**Winship Avenue Bridge over San Anselmo Creek Bridge Replacement Project
(Bridge No. 27C0074) *Initial Study/Proposed Mitigated Negative Declaration***

RE: WINSHIP AVENUE BRIDGE OVER SAN ANSELMO CREEK REPLACEMENT PROJECT
(BRIDGE NO. 27C0074) INITIAL STUDY/MITIGATED NEGATIVE DECLARATION COMMENT

Site Inspection Summary Memo

San Anselmo Flood Risk Reduction Project – Residential Scale Flood Risk Mitigation

SAN ANSELMO FLOOD RISK REDUCTION PROJECT FLOOD SURVEY

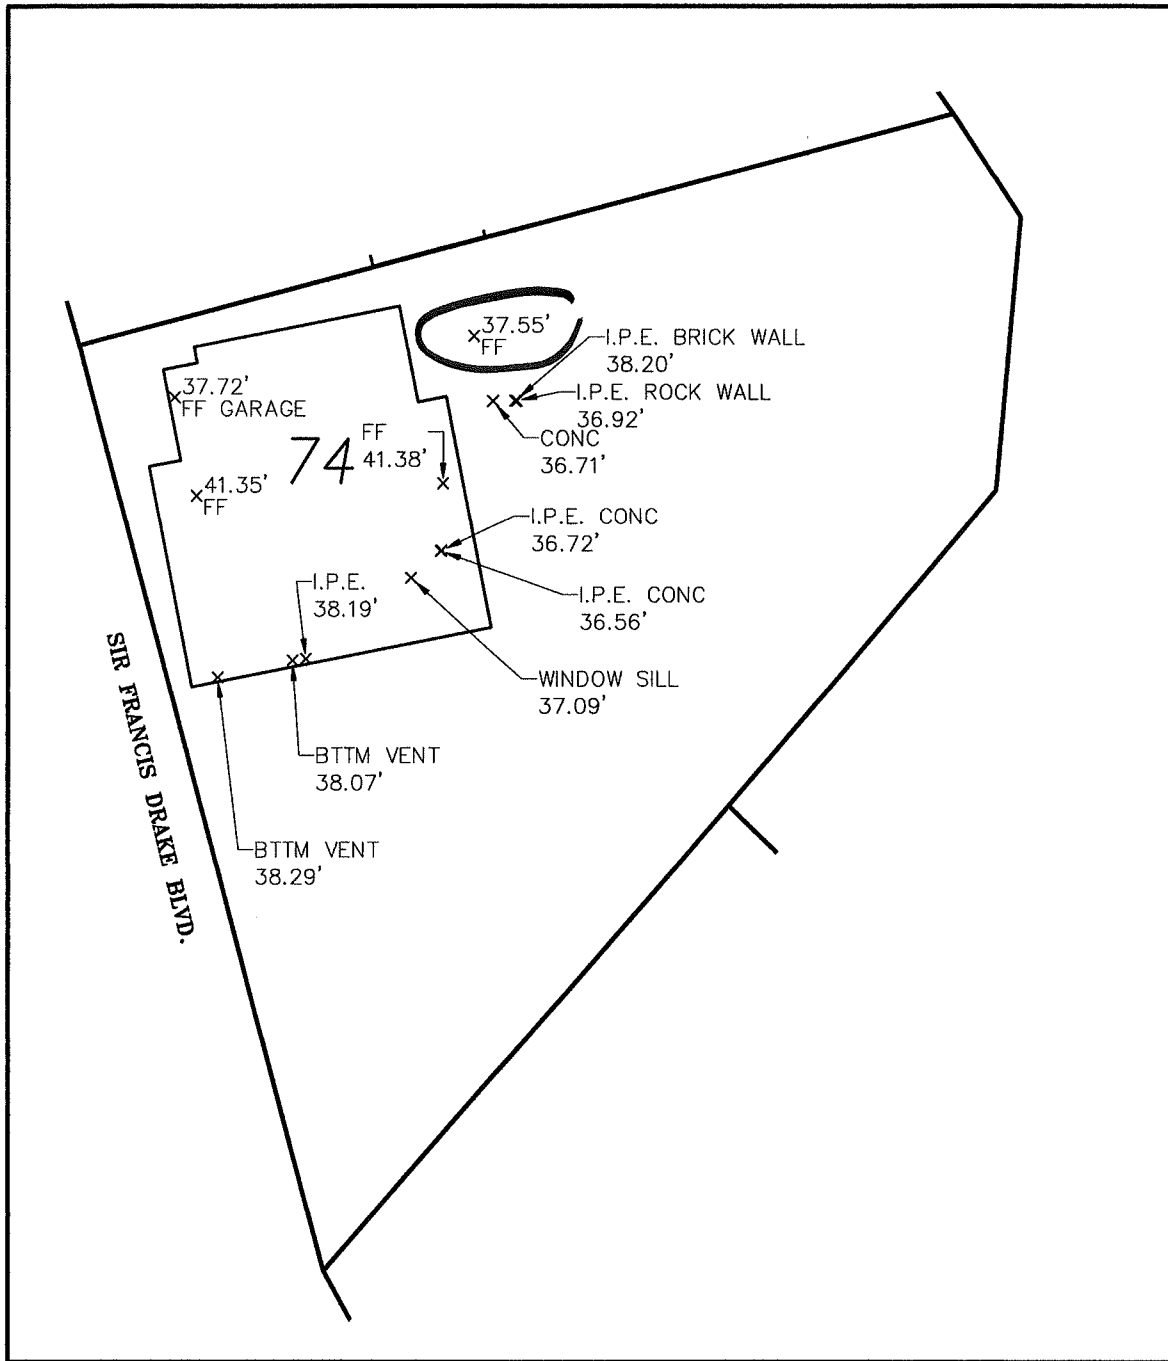
To make sure I understand. The documents that were published for consideration by the Town did not contain the correct elevation of my house? The town was notified but what elevation was used in the calculation that is being present to the Town Council for approval (ie for the record)? I am very concerned that all these irregularities are making it impossible to follow what is actually going on and what information is used to make decisions regarding my property.

Wanted to make sure you were all aware that the county has been using the wrong lower first floor elevation for my house at 74 sir Francis drake. When Hugh came out to my house last month he and I agreed the county was using the wrong data point and for some unknown reason was not using the bedroom in the lower level of my house. Hugh please confirm to Richard. Richard I noticed the staff report uses the wrong fff elevation also. Please all confirm receipt and Hugh confirm my statement regarding wrong elevation being used at my property. Time is of the essence.

The County Flood Control District notified us of the correction last month but the older version of the memo was inadvertently included in the staff report. Joe is forwarding your email to Town Council this morning.
